ADDENDUM:

***STATE SIGNIFICANT
DEVELOPMENT ASSESSMENT
Mt Thorley Continuation Project
(SSD-6465)***

Environmental Assessment Report
Section 89E of the
Environmental Planning and Assessment Act 1979
May 2015

Figure 1: Measured low frequency noise spectra compared to modified DEFRA curve

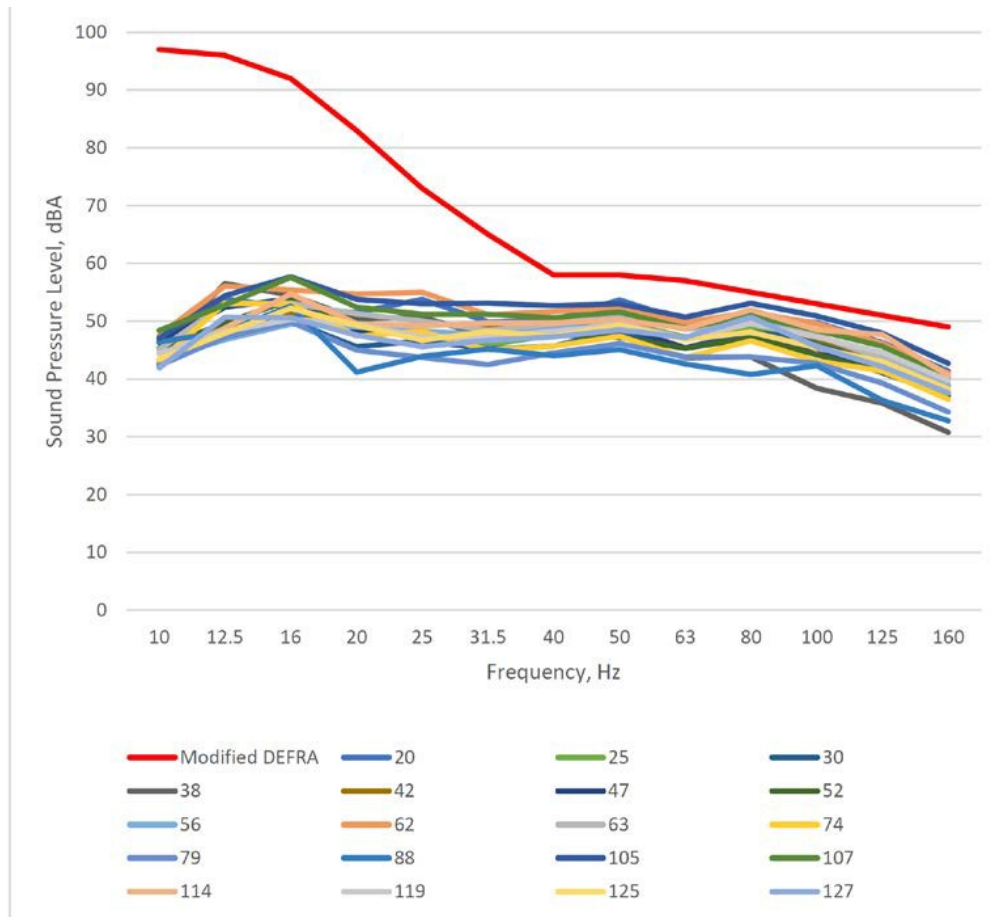
The audit indicates that C – A levels do exceed the 15dB threshold levels at all of the monitoring locations in Bulga Village. However, the LFN levels were found to comply with the modified⁴ DEFRA curve thresholds at all receivers. An example of the monitoring results against the modified DEFRA curve at one of the key residences in Bulga is shown in Figure 1 below.

The dBC levels were found to comply with the Broner criteria at all receivers, with the exception of some minor (0.3dB) exceedances of the 60dB 'desirable' criterion in a small number of measurements.

In considering this matter, it is important to note that the dBC levels measured by Wilkinson Murray (and the dB levels used for comparison against the DEFRA curve thresholds) are total noise levels from all of the mines in the area, including Mt Thorley, Warkworth, Bulga, Wambo and Hunter

In consideration of the above, the Department is satisfied that measured and predicted LFN levels associated with the existing mine and the Mt Thorley Continuation Project are below the annoyance thresholds based on contemporary LFN assessment methods, and therefore that LFN is unlikely to result in any unacceptable noise impacts in the surrounding area.

Figure 1: Loders Creek Aboriginal Cultural Heritage Conservation Area

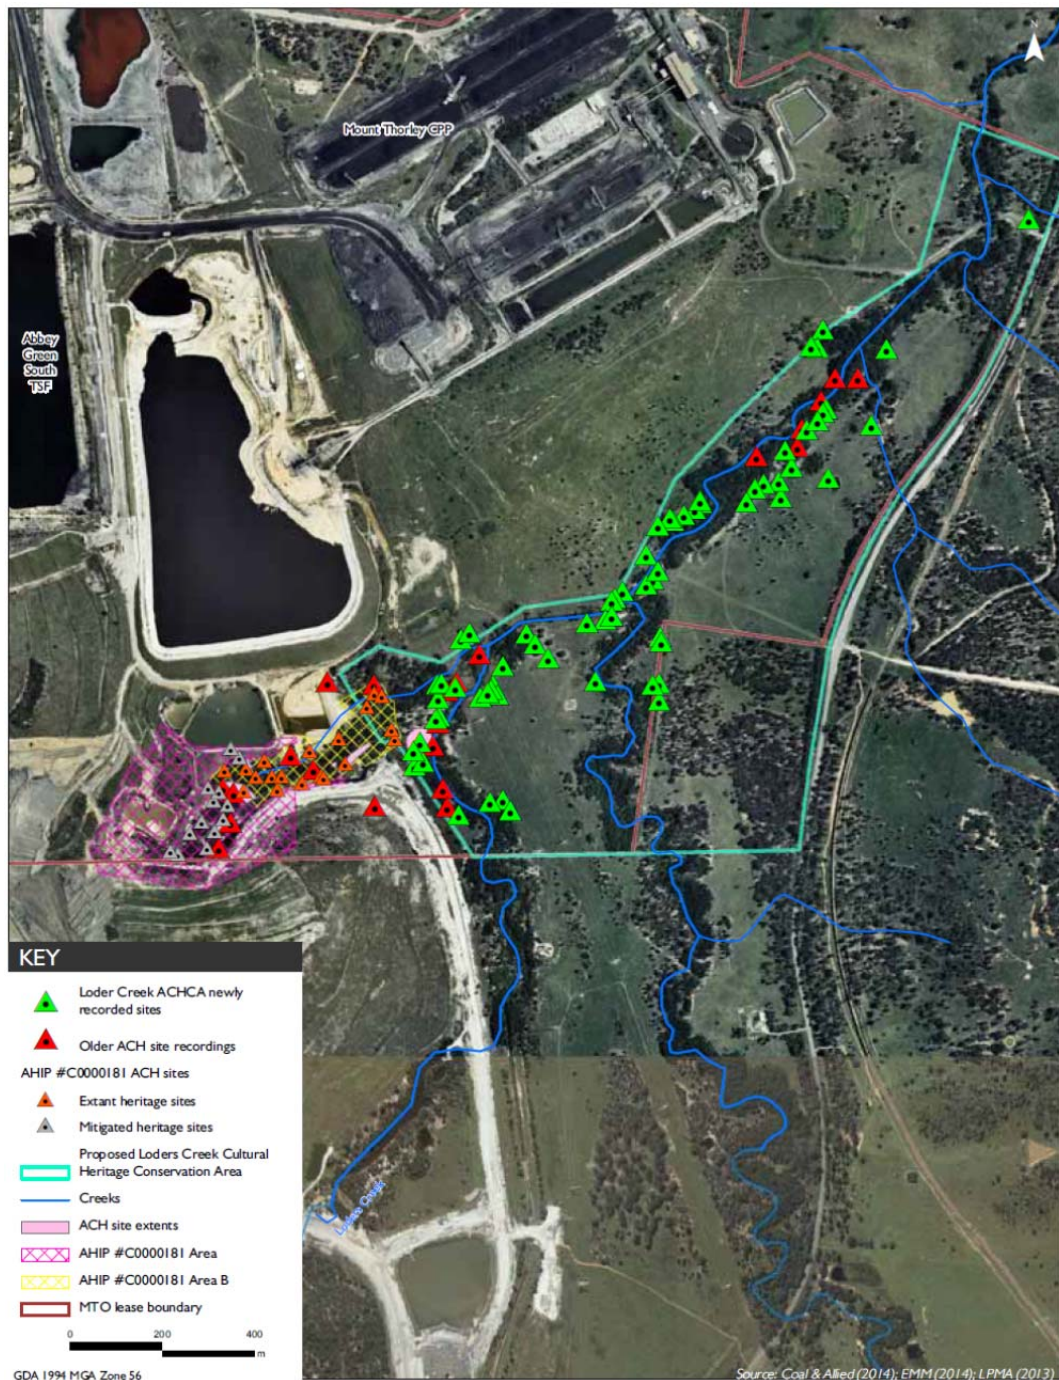
The additional surveys, undertaken in consultation with the Mt Thorley Warkworth (MTW) mine complex's Cultural Heritage Working Group (CHWG), identified 66 Aboriginal sites within the ACHCA, including isolated stone artefacts, artefact scatters and 2 knapping floors each comprising hundreds of artefacts. Ten sites identified in previous surveys (conducted in 1983 and 1995) were also re-recorded to update their details. The recorded sites are shown on Figure 1 below.

The PAC also noted that part of the proposed ACHCA is outside the site boundary for the project. MTO's response confirms that whilst outside the site boundary, the entire area of the proposed ACHCA is located on land owned and managed by Rio Tinto (Coal & Allied).

The Department's recommended conditions require MTO protect and secure the ACHCA in perpetuity via a conservation agreement or agreements under the *National Parks & Wildlife Act 1974*. The Department is satisfied that such an agreement would provide for the long-term conservation of the area. Whilst management measures would be facilitated under such an agreement(s), the Department has amended the Aboriginal Heritage Management Plan condition (ie. condition 28 of schedule 3) to require the plan to include measures to protect the Aboriginal cultural heritage values of the ACHCA.
